Access Compliance Report

Public Rights-of-Way

Intersection ID: 53351	Main Street: MARVIN_RD	Cross Street: SAPPHIRE_HILL_LN	Location: NE
ADA ID: E0728D57E6C2	Ramp Type: Perp	Initial Pass/Fail: Fail	Overall Compliance: No
		Severity Score: 10

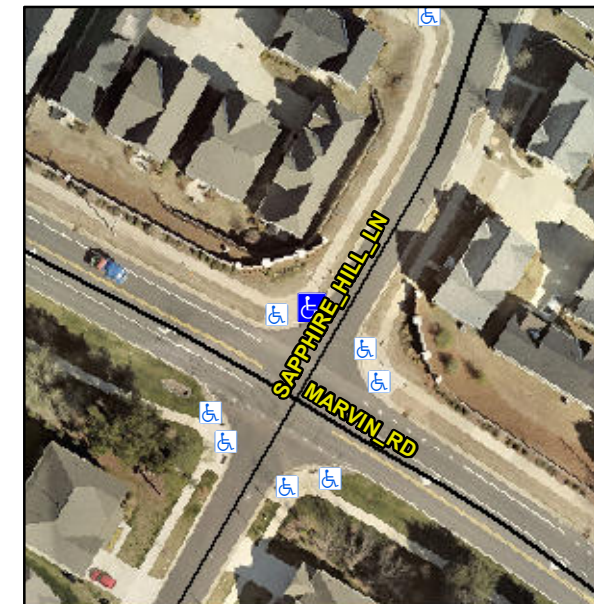
Not Found, R304.5.1, R304.5.3

Compliance	Description	Data	Compliance	Description	Data
N/A	Ramp Length (in)	67.5	Yes	Ramp Slope (%)	5.3
No	Ramp Width (in)	47.0	No	Ramp XSlope (%)	3.1
N/A	Flare Type LT	N/A	N/A	Flare Type RT	N/A
N/A	Flare Slope LT (%)	N/A	N/A	Flare Slope RT (%)	N/A
N/A	Flare Traversable LT?	N/A	N/A	Flare Traversable RT?	N/A
N/A	Landing Length (in)	N/A	N/A	DWS Provided?	N/A
N/A	Landing Width (in)	N/A	N/A	DWS Contrast?	N/A
N/A	Landing Slope (%)	N/A	N/A	DWS Length (in)	N/A
N/A	Landing X Slope (%)	N/A	N/A	DWS Full Width?	N/A
N/A	Landing Curb? (Y/N)	N/A	N/A	DWS Offset (in)	N/A
N/A	Shared Landing?	N/A			
N/A	Gutter Ponding?	N/A	N/A	Gutter Slope (%)	N/A
N/A	Gutter Lip Ht (in)	N/A	N/A	Gutter X Slope (%)	N/A
N/A	Painted X Walk1?	No	N/A	Painted X Walk2?	N/A
	X Walk 1 Direction	To SE		X Walk 2 Direction	N/A
N/A	X Walk 1 Width (in)	N/A	N/A	X Walk 2 Width (in)	N/A
	X Walk 1 Slope (%)	3.8		X Walk 2 Slope (%)	N/A
	X Walk 1 X Slope (%)	4.4		X Walk 2 X Slope (%)	N/A

Remove & Replace Entire Ramp.
